FOR PERCOLATION TESTING AND SITE EVALUATION

MEMORANDUM

RE: 16780 A.E. Mullinix Rd, Lot 1
Sand Mound site plan

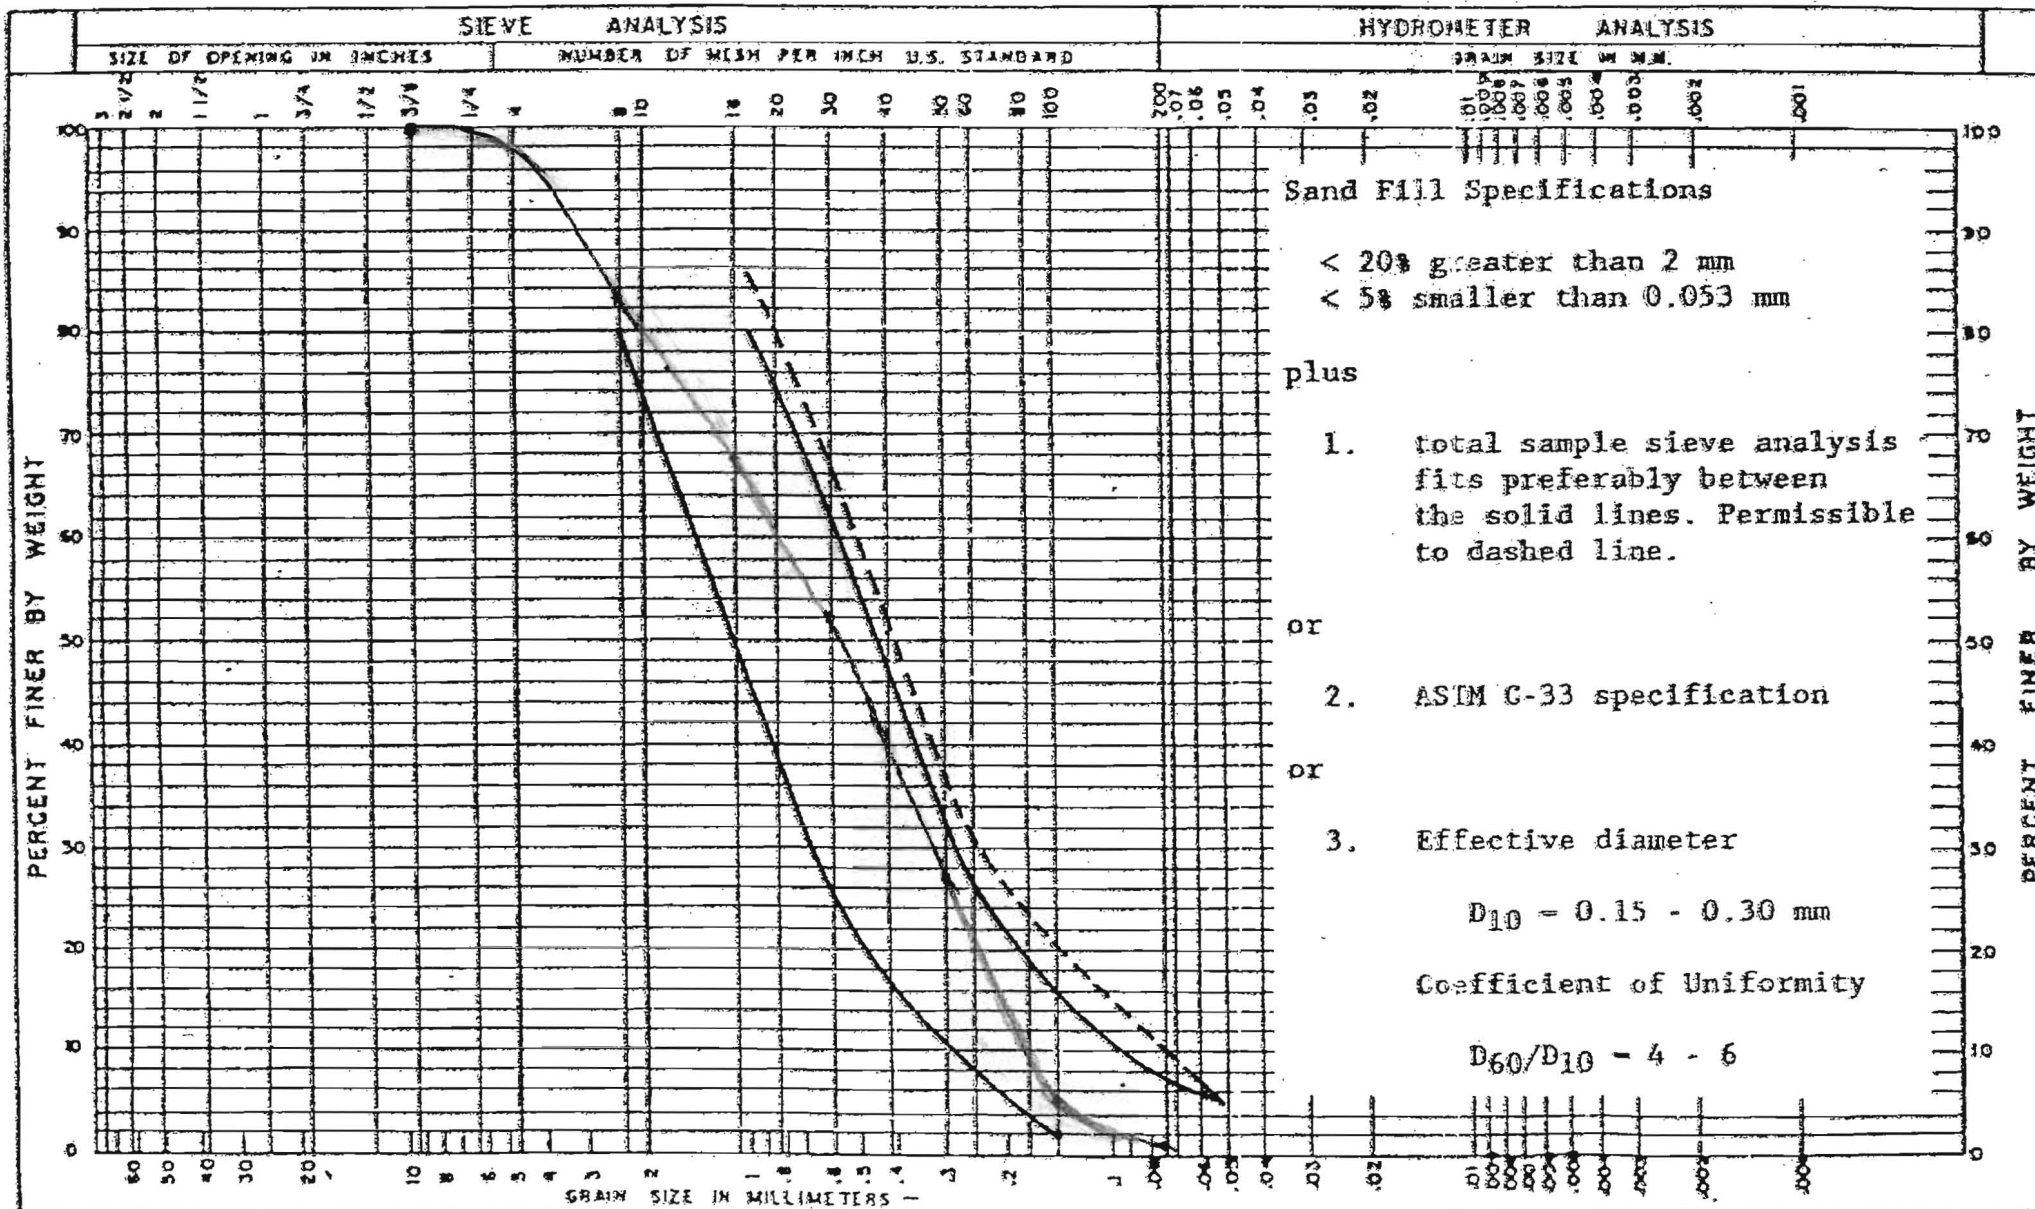
1. Site plan needs to show 1' contour intervals
2. Relocate force main position (see enclosed plan)
3. Remove alternative sand references in summary section
4. Elevations needed at the noted points on sand mound cross-section
5. Soil loading rate should be 0.75 gal/ft²/day
6. Need inlet baffle on septic tank (Howard County Code Sec 3.810 D)
7. Need elevations on hydraulic profile at specific points versus as a side bar
8. Alarm elevations need to be shown on pump tank
